From: Robert Kuhfuss [REDACTED]
Sent: Thursday, February 12, 2026 7:24 AM
To: Chris Jacques <chris.jacques@peoriaaz.gov>
Cc: LuAnn Kuhfuss [REDACTED]
Subject: Kuhfuss comments re PIC

RE: Peoria Innovation Core – Edge Treatment, Parcel 1-P

Edge Treatment – Parcel 1P

20-FOOT HEIGHT RESTRICTION

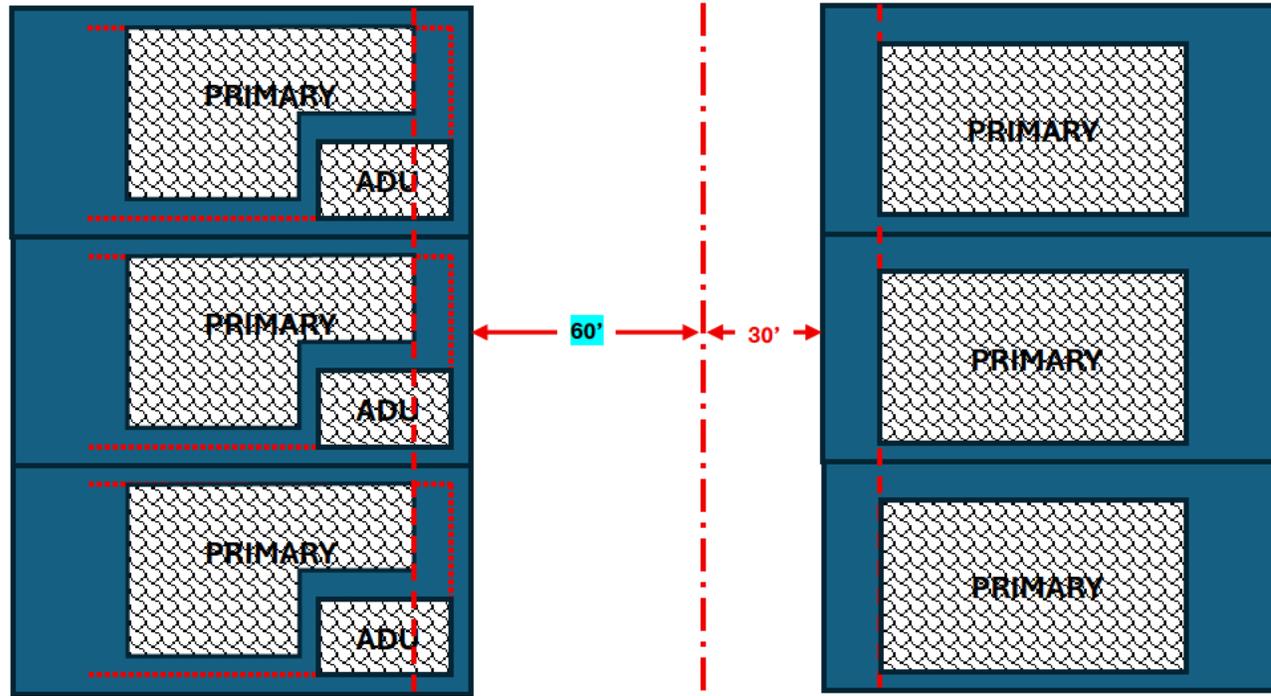
Slide 10 depicts the same edge condition except that the new residence is limited to 20 feet in height, which would likely develop as a single-story residence. If that owner were to choose to build an ADU, using 8-foot ceilings, they could construct a two-story ADU, as is their right. While this is an improvement, the houses will still be considerably close to the existing residences, especially taking into account the 15-foot rear setback for the primary residence and the 5-foot setback for the ADU. Slide 11 depicts the condition where both a 20-foot height restriction and a 60-foot buffer would exist. This will result in a distance of 110 feet between the existing residences and the new ADU, with an additional 10 feet to the new primary residence.

- ❖ Right side denotes existing condition along north side of Pradera Subdivision.
- ❖ Left side denotes potential alternative condition for Parcel 1P:
 - 30' Landscape Buffer
 - **20' Building Height**
 - ✓ **20' High Primary Residence**
 - ✓ **20' High Accessory Dwelling Unit**
 - 5' Setback on ADUs per ARS

“NO BUILDING, OR PORTION THEREOF, LOCATED WITHIN 180 FEET OF THE SOUTHERN BOUNDARY OF PARCEL 1P MAY EXCEED TWENTY (20) FEET IN HEIGHT. THE 20-FOOT HEIGHT RESTRICTION SHALL BE INCLUDED ON BOTH THE PRELIMINARY PLAT AND FINAL PLAT, AND ALL EFFECTED PLOT PLANS THEREAFTER.”

20' BUILDING HEIGHT AND 60-FOOT LANDSCAPE BUFFER

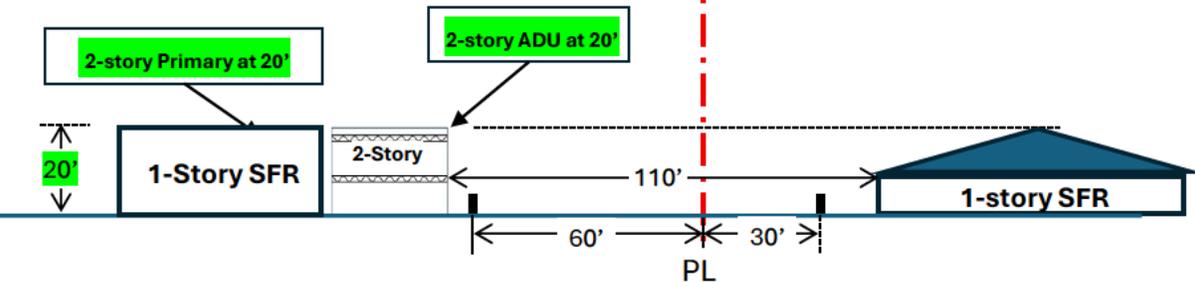
- ❖ Right side denotes existing condition along north side of Pradera Subdivision (Lots 38 through 51).
- ❖ Left side denotes potential alternative condition:
 - 60' Landscape Buffer
 - 20' Building Height
 - 20' High Primary Residence
 - 20' High Accessory Dwelling Unit
 - 5' Setback on ADUs per ARS

“Parcels 1N, 1O, and 1P shall have a landscaped **NATURAL OPEN SPACE** buffer of no less than ~~60’~~ 30’ along the southern and eastern boundary conditions abutting **THE COMMUNITIES OF** Pleasant Valley and West Wing **MOUNTAIN**. **THE REQUIRED NATURAL OPEN SPACE BUFFER SHALL BE INCLUDED ON THE PRELIMINARY PLAT AND FINAL PLAT FOR PARCELS 1N, 1O, AND 1P AS A SEPARATE TRACT FOR THAT PURPOSE. THE NATIVE VEGETATION AND NATURAL TOPOGRAPHY WITHIN THE NATURAL OPEN SPACE BUFFER SHALL BE PRESERVED TO THE GREATEST EXTENT POSSIBLE AND A PLAT NOTE TO THAT EFFECT SHALL BE INCLUDED IN THE PRELIMINARY PLAT, FINAL PLAT, AND ALL GRADING AND LANDSCAPE PLANS FOR THE EFFECTED PARCELS.**”
